PN 20-166985
V07 House Start Up Renovation
Type of Original Notice: Request for Bids
Notice Number: 20-166985

ADDENDUM 1

V07 HOUSE START-UP RENOVATION

DEMOLITION PLAN FIRST FLOOR

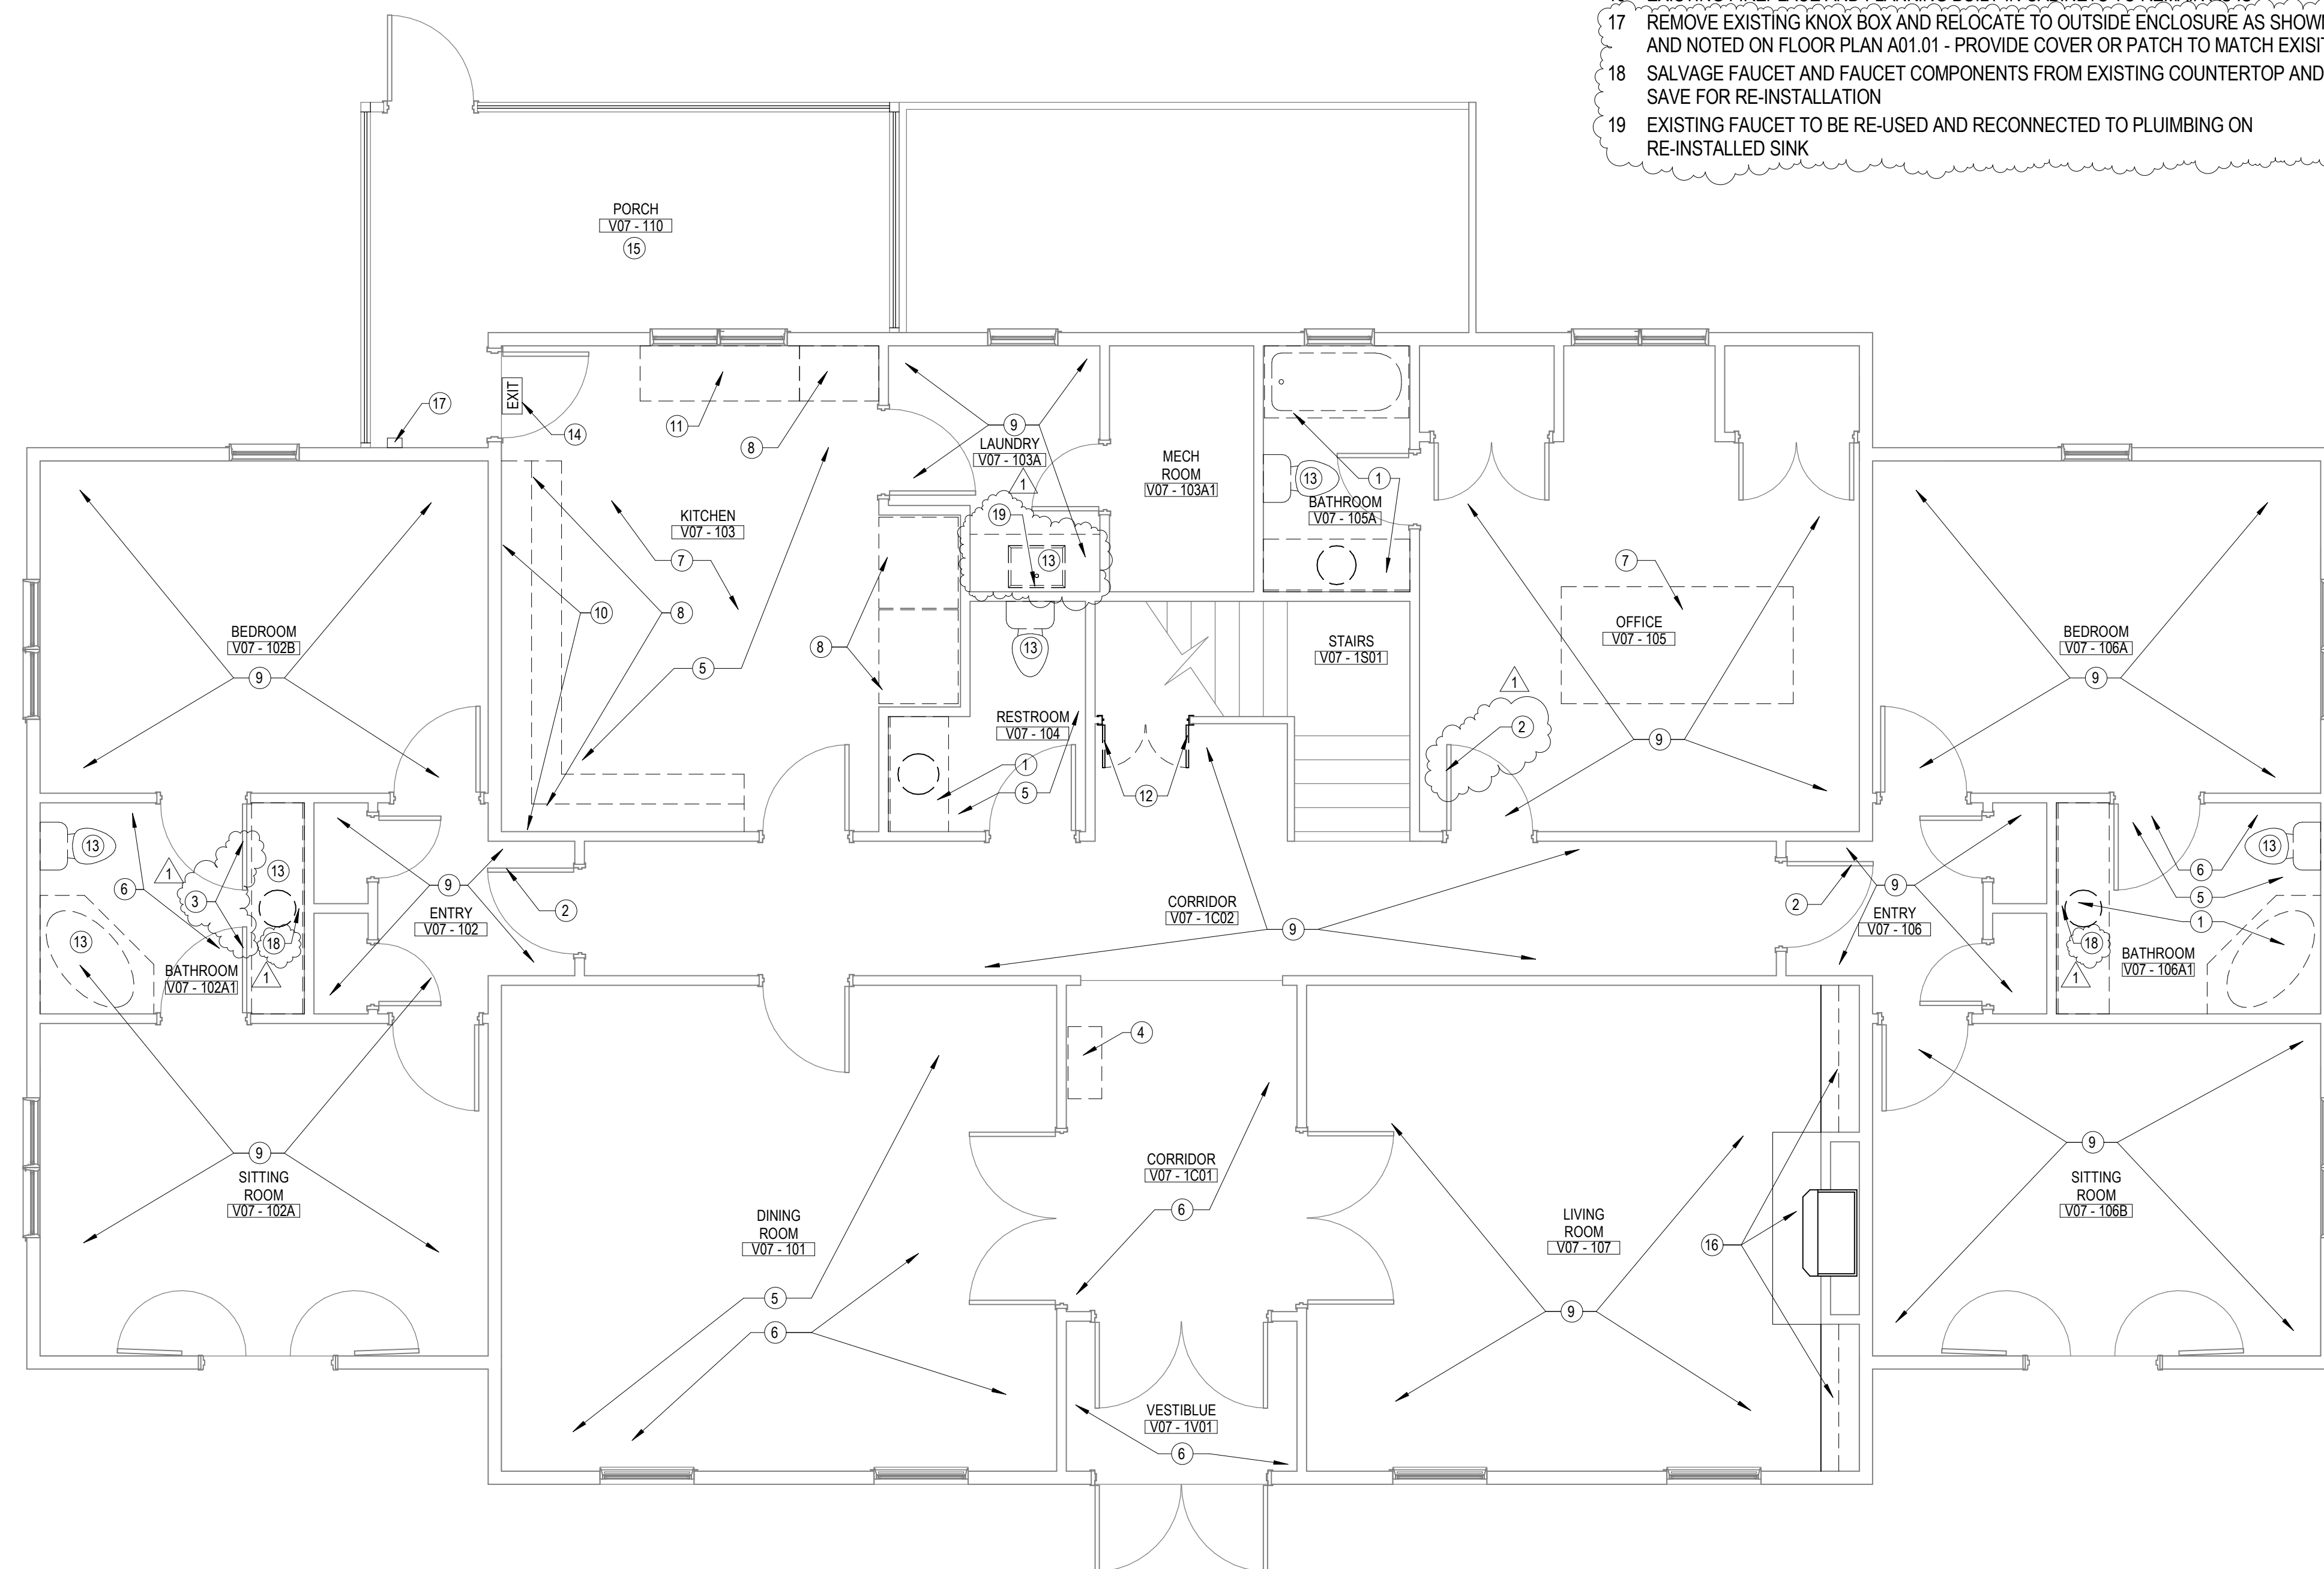
- AD01.01** – Deleted original wording for Demo Key Note #3 (existing Mechanical room door now to remain) and replaced Note #3 to add scope for the two Bathroom doors to V07-102A1.
- AD01.01** – Added note to Demo Key Note #11 to patch wall at modification.
- AD01.01** – Added Demo Key Note #2 to door to Office V07-105.
- AD01.01** – Added Demo Key Note #17 regarding relocation of Knox Box.
- AD01.01** – Added Demo Key Note #18 noting existing bathroom sink faucets for Bathrooms V07-102A1 and V07-106A1 to be salvaged along with plumbing components and reinstalled.
- AD01.01** – Added Demo Key Note #19 noting that Laundry sink faucet is to be salvaged and re-connected to plumbing.
- A01.01** – Added note to Floor Plan Key Note #6 indicating that the existing bathroom doors to be re-painted.

FLOOR PLAN - FIRST FLOOR

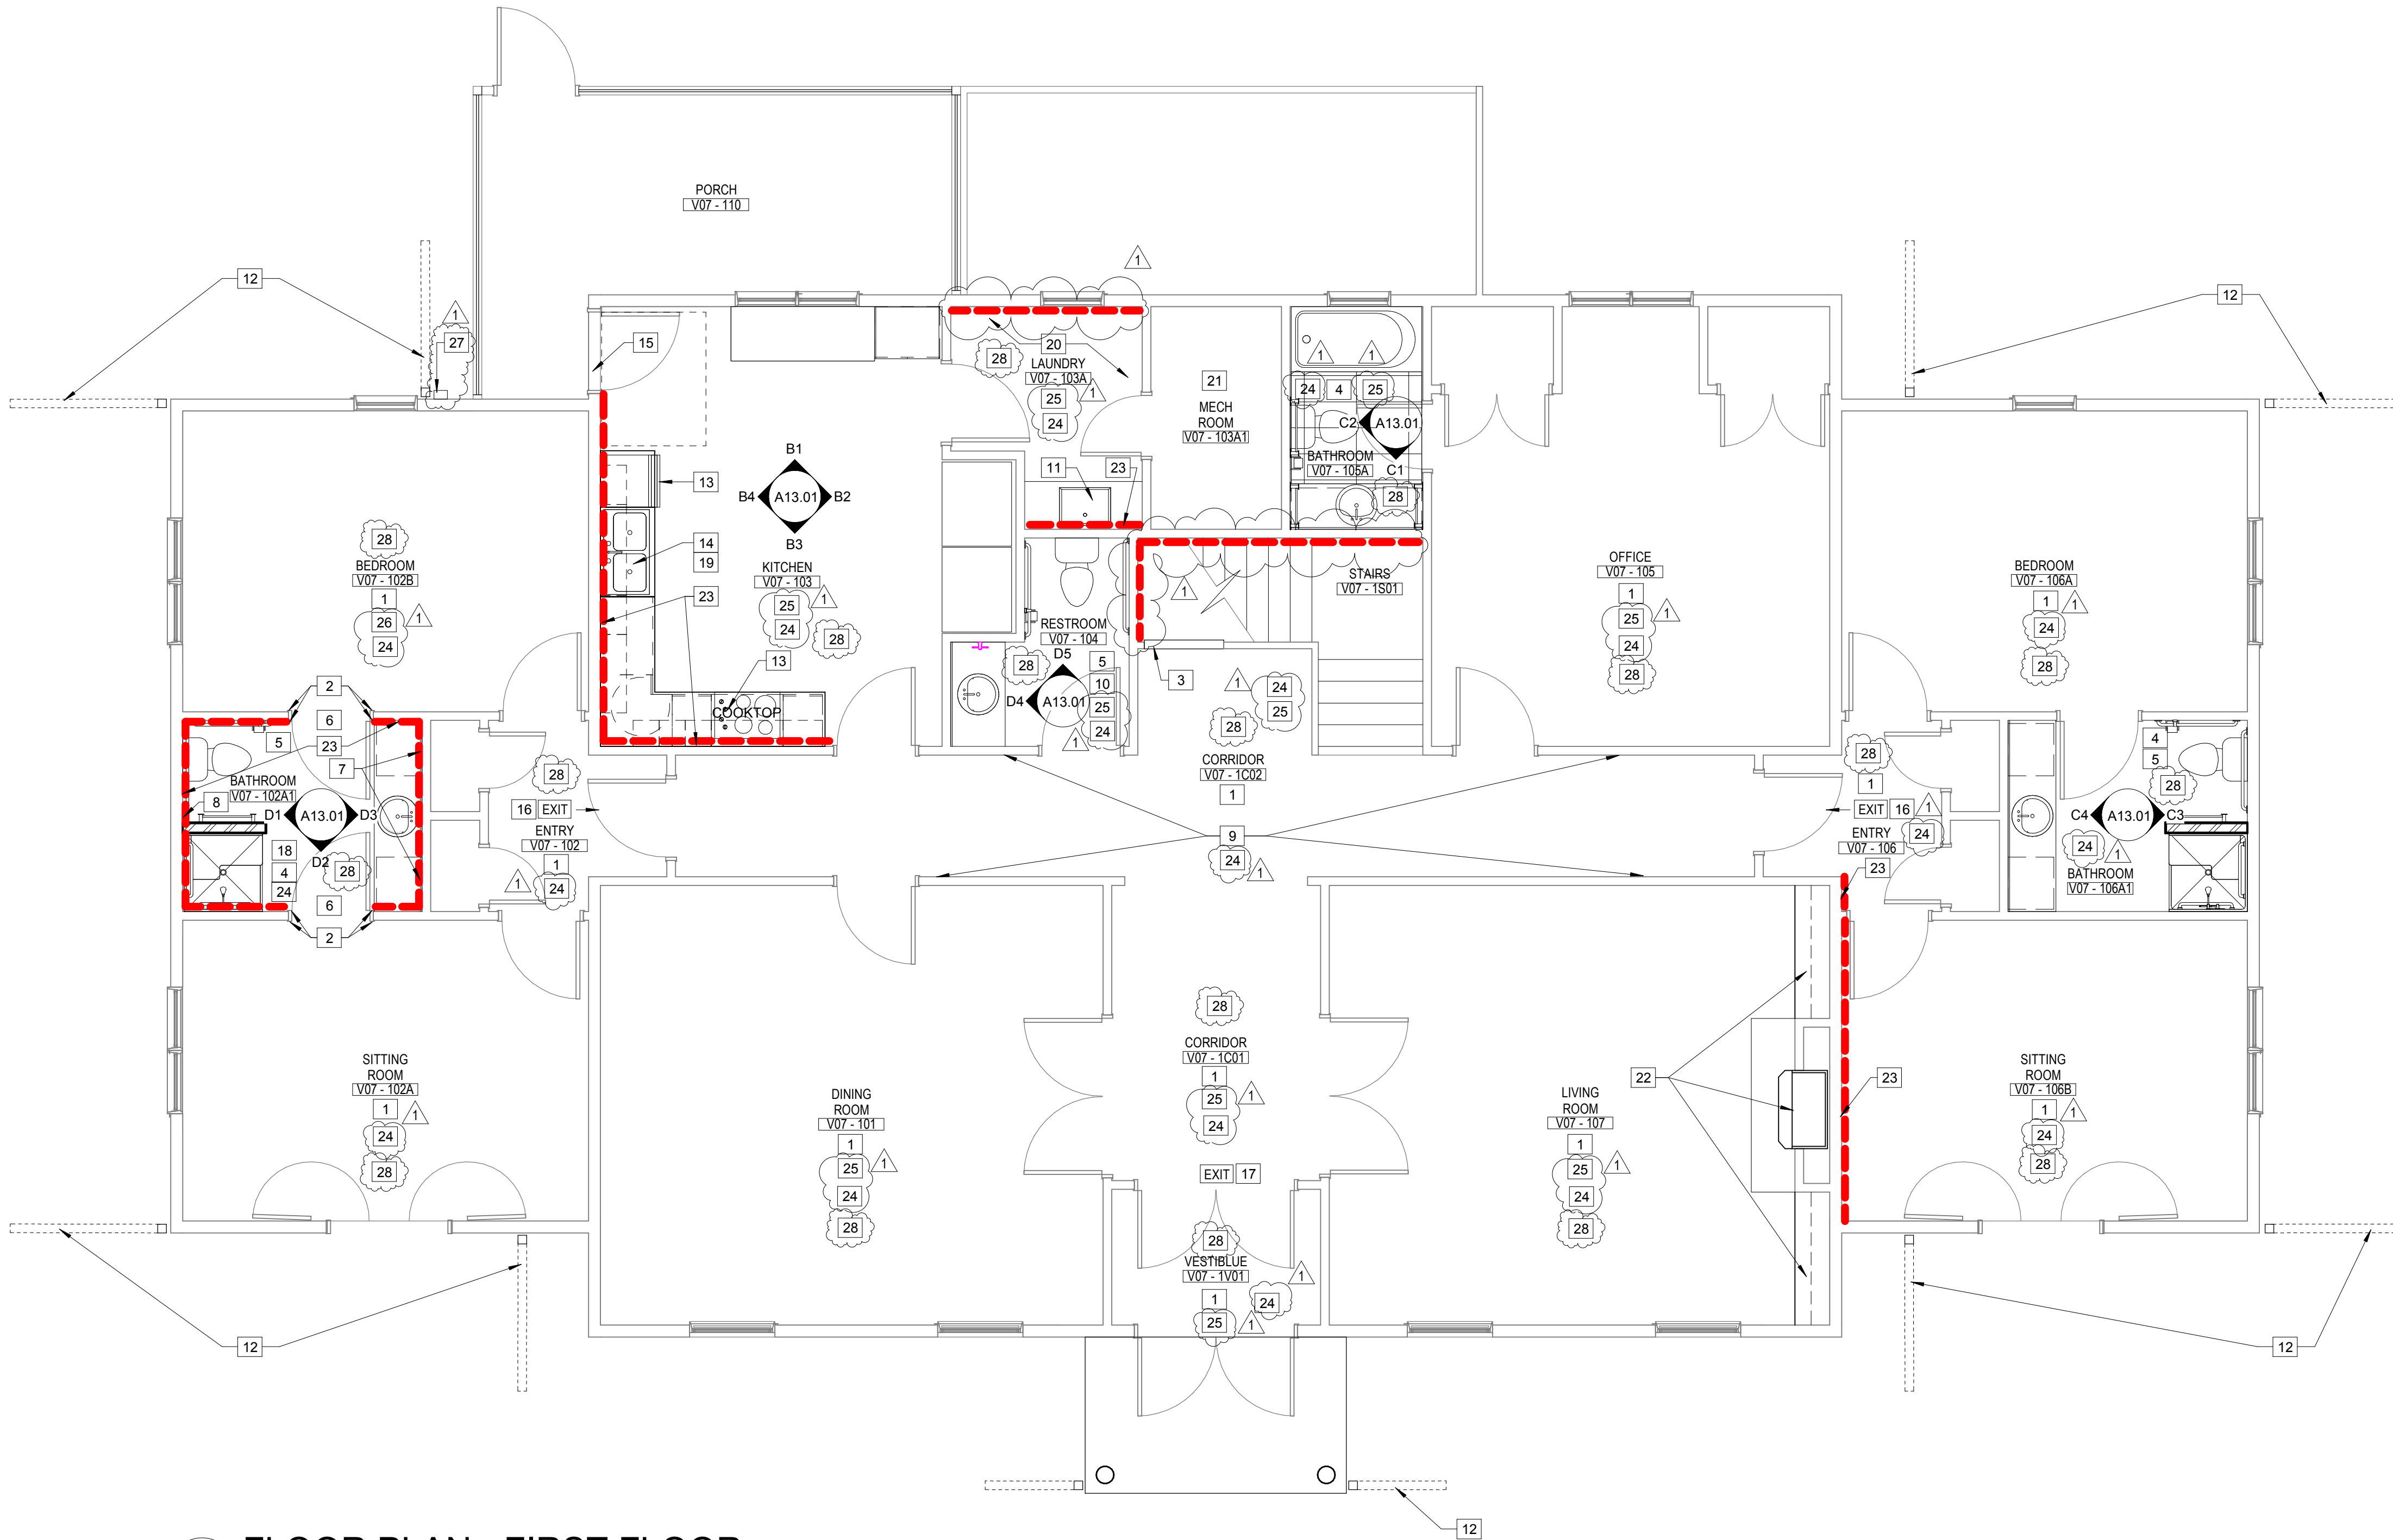
7. Is there any HVAC mechanical work? *Response: Yes, there is mechanical work in the crawl space as noted on A01.01 – Crawl Space Scope.*
8. Do the ceiling or floor HVAC grills (supply or return) need to be replaced? If so, is there a spec to match? *Response: Yes, approximately (12) floor registers need to be replaced to match existing. They are decorative brass registers.*

15. Please confirm all mechanical duct wrap has been demolished in the crawl space on A01.01 Crawl Space scope note 2. *Response: We believe that duct wrap in the crawl space needs to be demolished – See Additional Information below.*

- A01.01** - Added note to Floor Plan Key Note #11 indicating that the salvaged laundry sink and faucet are to be reinstalled in a new solid surface countertop.

- A01.01** – Deleted original wording for Demo Key Note #24 (light fixture scope at ceiling of Bathroom V07-102A1 which is not needed) and added new Floor Plan Key Note #24 regarding miscellaneous wall patching and keyed on Floor Plan.

- A01.01** – Added Floor Plan Key Note #25 regarding replacing decorative floor registers and keyed on Floor Plan.
- A01.01** – Added Floor Plan Key Note #26 regarding replacement of a removed smoke detector.

- A01.01** – Added Floor Plan Key Note #27 regarding relocation of the Knox Box.
- A01.01** – Added to Floor Plan key note #23 to north wall of Laundry and under Stairs.

- A01.01** – Added Crawl Space Scope note #6 regarding removal and replacement of insulating pipe wrap in crawl space.
- A01.01** – Plumbing Fixtures: Changed bathroom faucet specification to match existing bathroom faucets. New bathroom sink faucet only required in Restroom V07-104 and Bathroom V07-105A. Bathrooms V07-102A1 and V07-106A1 to have existing faucets reinstalled/reconnected at new sinks in new solid surface countertops.

- A01.01** – Plumbing Fixtures: Added Kitchen sink faucet.
- A01.01** - Added to Project Alternate #1 note regarding contractor to carry minimal amount of sheathing as part of alternate.

- To remove & replace paper backed insulation between the floor joists using **R38** per Crawl Space Scope notes #1 and #3 on A01.01.
- To remove and replace insulating pipe wrap in the Crawl Space per Crawl Space Scope note #6 on A01.01.
- To remove and replace all damaged ductwork and duct insulation in crawl space per Crawl Space Scope notes #2 and #5 on A01.01.
